1 Longwalk
Design Response
30.01.24

Prepared by **Barr Gazetas** for

Royal 1 Longwalk Ltd

The Design Review Panel for 1 Longwalk took place on 5th October 2023 with written feedback received on the 19th October.

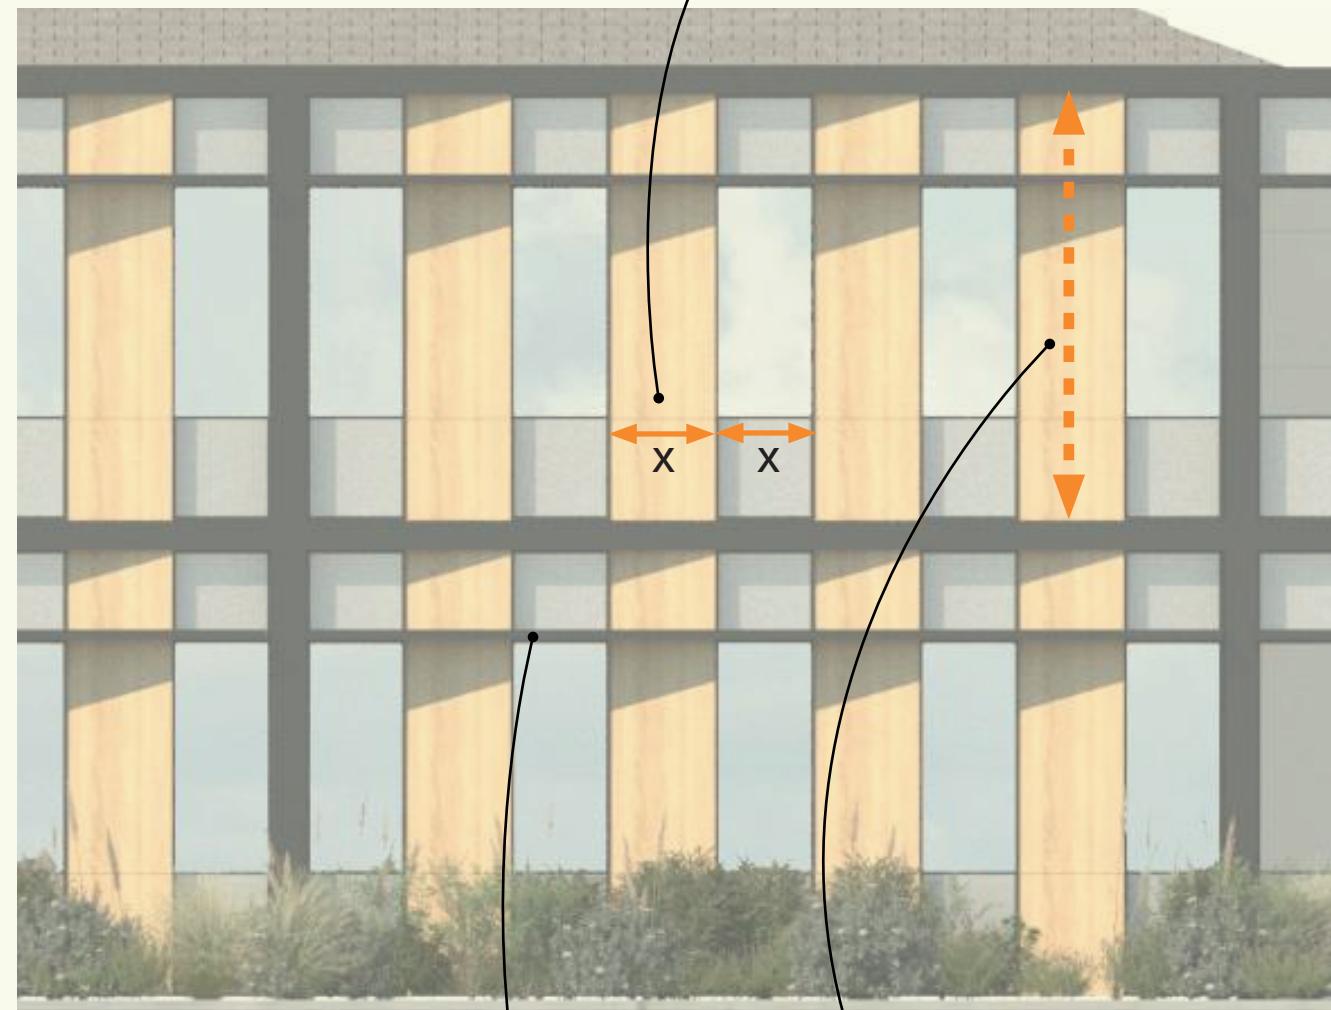
The revised proposals respond to DRP feedback that the facade design should more directly respond to environmental aspect and respond accordingly. We have revised the proposals so that there is an overall 'framework' to the cladding that allows the facades to vary in response without interrupting the overall consistent and holistic appearance.

The cladding to each elevation now provides meaningful, beneficial shading to the facade - horizontal shading to the south and vertical shading to the east and west. This assists in managing heating load in the office space and in turn reduces operational energy.

Extended brise soleil framing
Flat facade panels

Angled cladding panels

Flat cladding panels

Submitted facade design

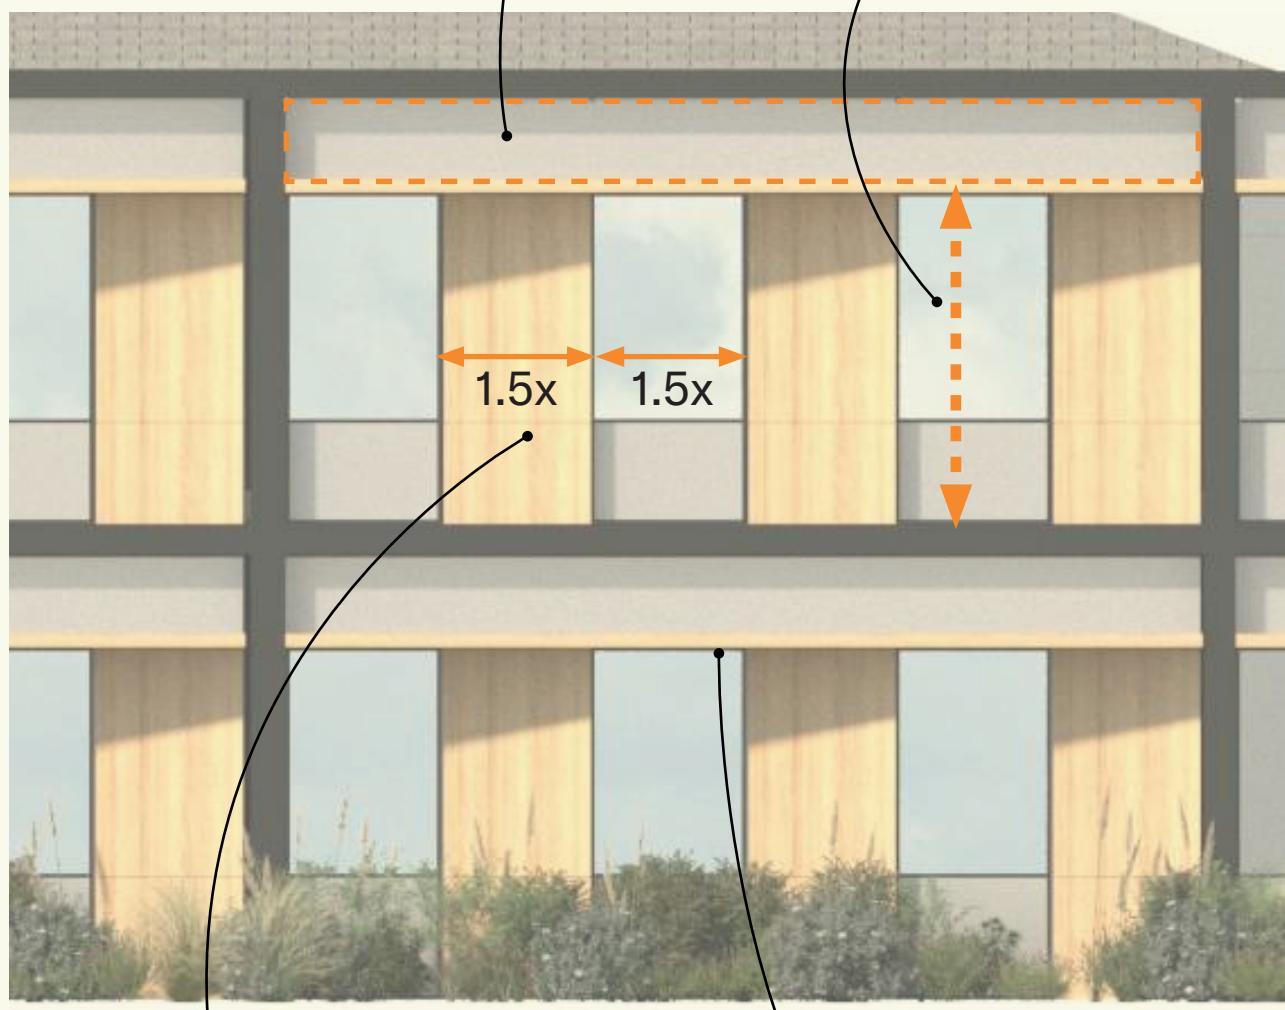
Narrow proportions create a strong and repetitive vertical emphasis to the cladding design

Vertical spandrels span the full height of the expressed frame adding to the vertical emphasis

The dark metal brise soleil adds weight and bulk to the elevations when viewed obliquely

Continuous horizontal banding at each floor level breaks up the verticality of the spandrel panels and glazing and adds a significant area of light coloured cladding, brightening the overall appearance.

The spandrel panels did not span the full height of the facade making them secondary to the horizontal floor banding and brise soleil.

DRP facade design

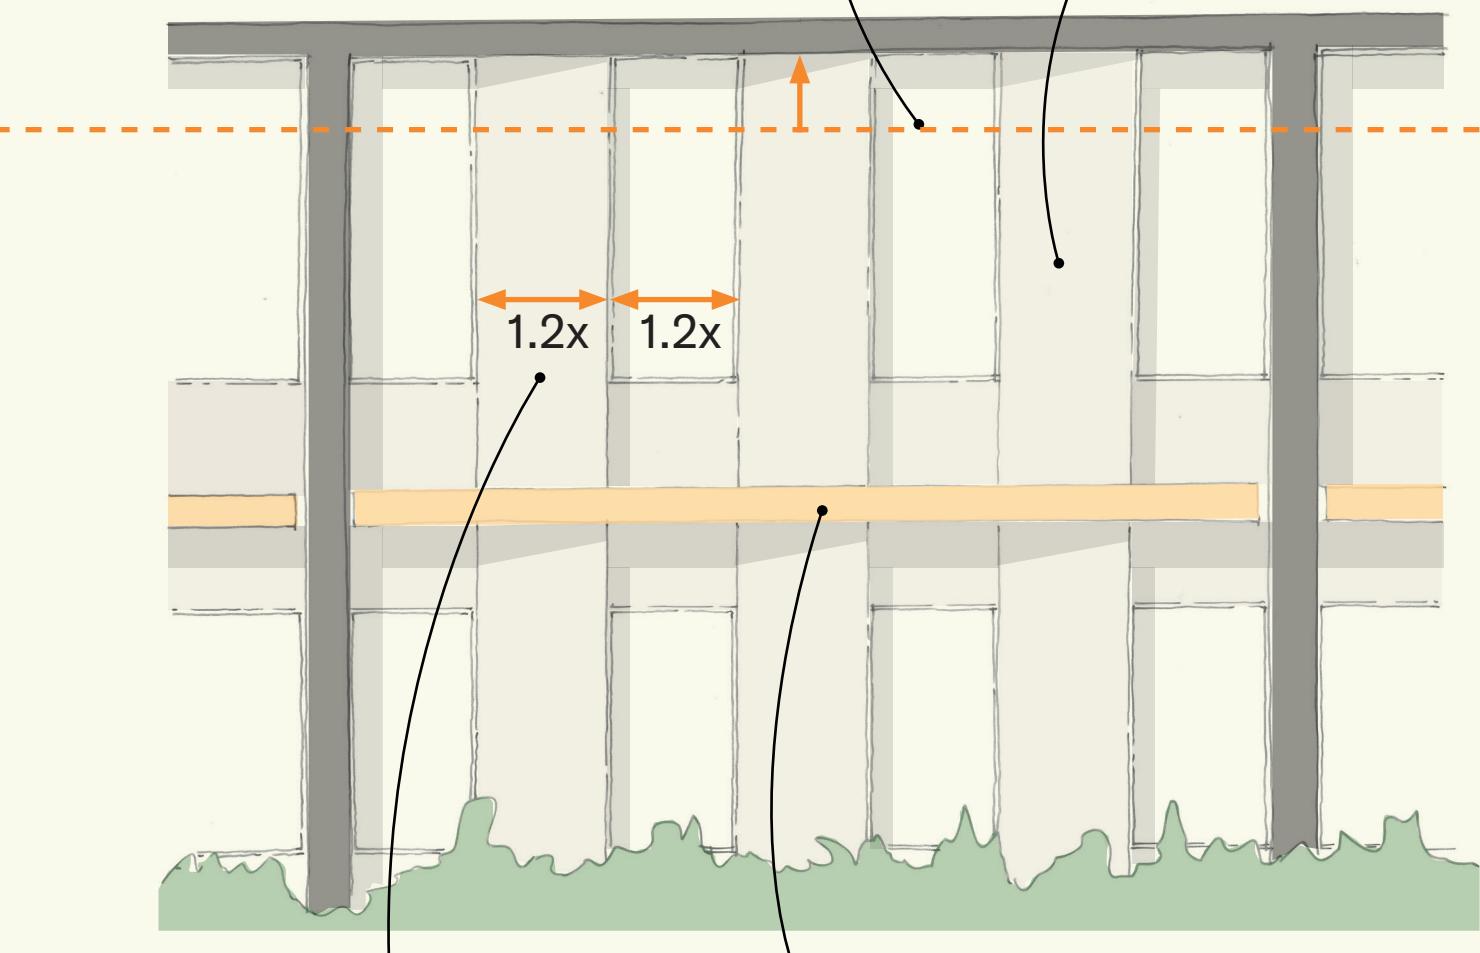
An increase in the width of the glazing and spandrel panels reduces the verticality of the facade and the repetitive 'striped' appearance.

We proposed a timber brise soleil to read a lighter element relative to the current metal version.

Window height maximised to simplify the design through the reduction in horizontal banding and to invoke the regular simplicity of the original design

Spandrel panels to be a single light off white colour. No differentiation between full height and under window panels to minimise banding contrast
